**PLANNING AND ZONING COMMISSION
CITY OF BETTENDORF
MAY 17, 2023 AT 5:30 PM
CITY HALL COUNCIL CHAMBERS
1609 STATE STREET**

TO: Planning and Zoning Commission
FROM: Mark D. Hunt, Community Development Director
RE: Case 22-097; 3150 Glenbrook Circle South - Site Development Plan Modification
DATE: May 17, 2023

Request: Major Change to an existing Site Development Plan (SDP)

SHEET TITLE
SITE PLAN

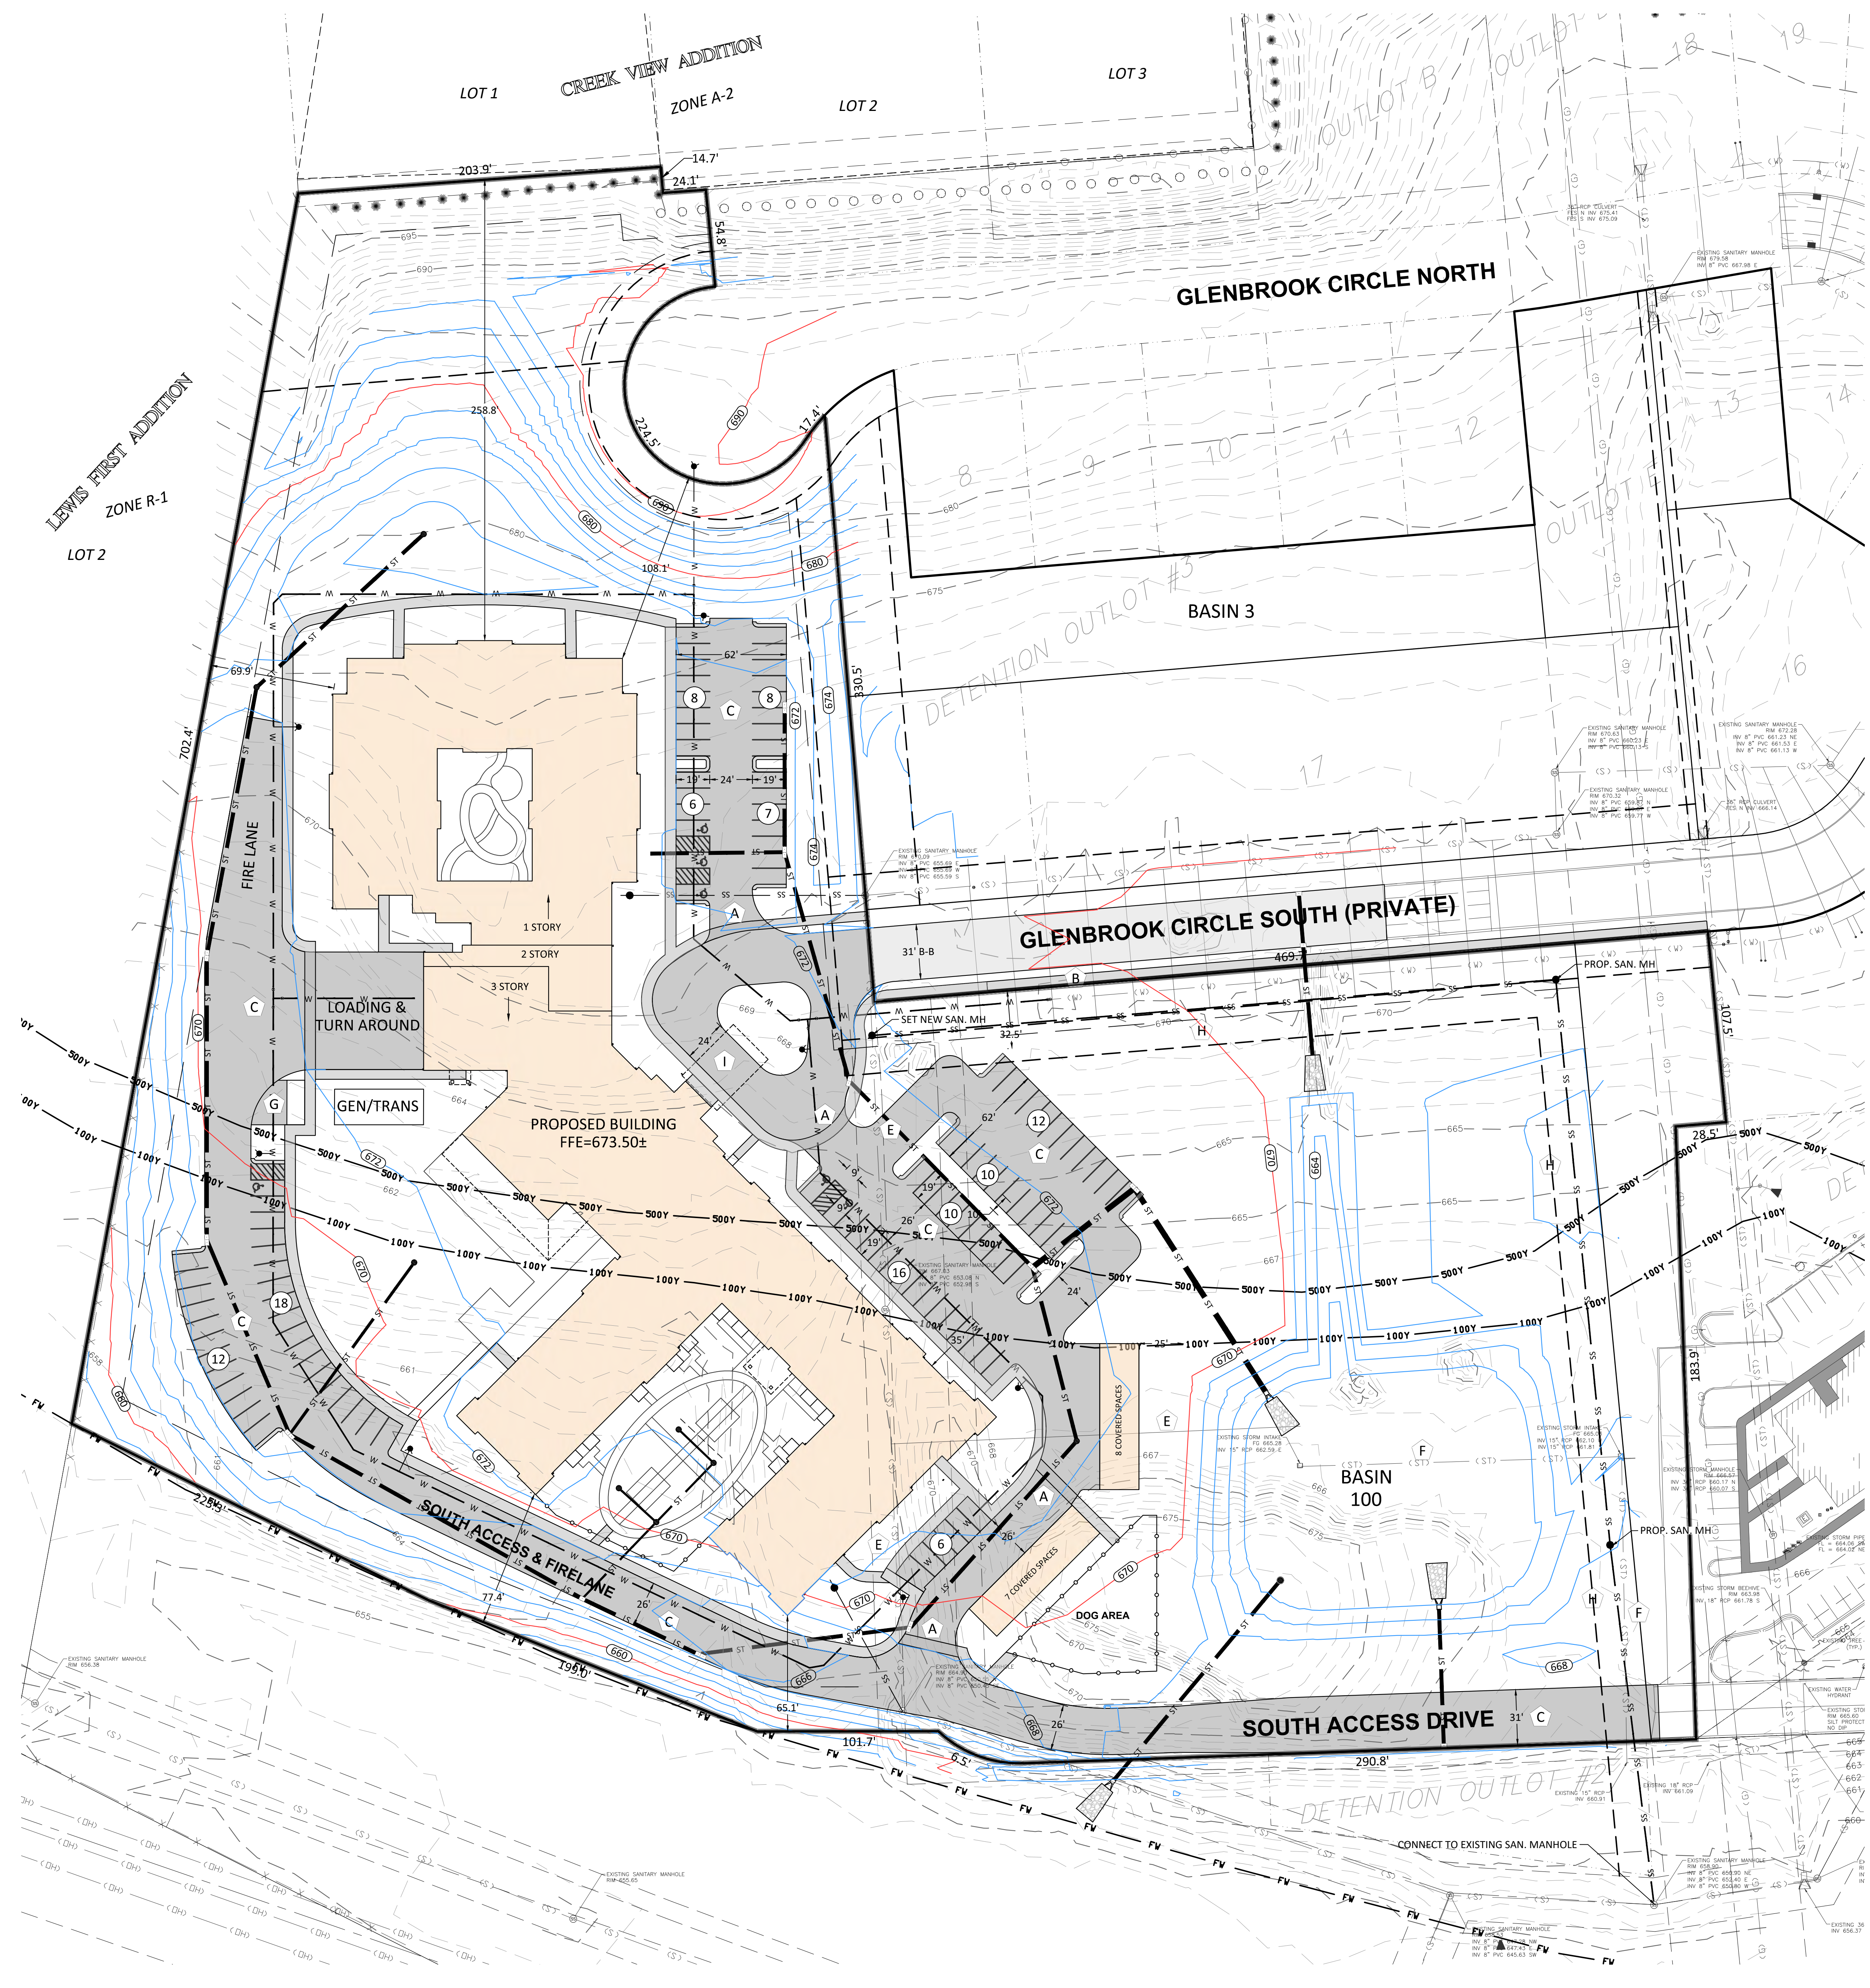
The approved Quartet SDP shows approximately 486 feet of frontage along Glenbrook Circle South matched to a lot width of roughly 486 feet. The proposed Major Change to the Quartet SDP reduces the frontage along Glenbrook Circle South to approximately 165 feet, while the lot width remains 486 feet. The proposed Major Change does not meet this criterion.

Staff contends the open space/drainage area is integral the Quartet's SDP and the Glenbrook Ridge DCA. The proposed Major Change appears to eliminate multiple trees from the Landscape Plan originally approved with the SDP. It also appears to remove buffering/transitioning, between the Quartet and the nearby townhomes and apartments. Changes to the existing drainage pattern would occur. The proposed Major Change does not meet this criterion.

The ability of the developer to provide the dog park as shown and required under the current SDP is severely limited by the proposed Major Change. Staff finds this to have a negative impact on the proposed Major Change.

The drainage area's pond and open space was a major focal point of the landscape aesthetic of the approved SDP. Removing this from the landscape has a significant impact to the look and feel of the built environment within the Glenbrook Ridge DCA. Staff finds this to have a negative impact on the proposed Major Change.

Staff recommends denial of the proposed Major Change to the Quartet's existing SDP. Allowing such a change would not align with the location and design criteria specified in City Code. The Major Change appears to conflict with required improvements such as the dog park and landscaping required under the existing SDP. The change would also present
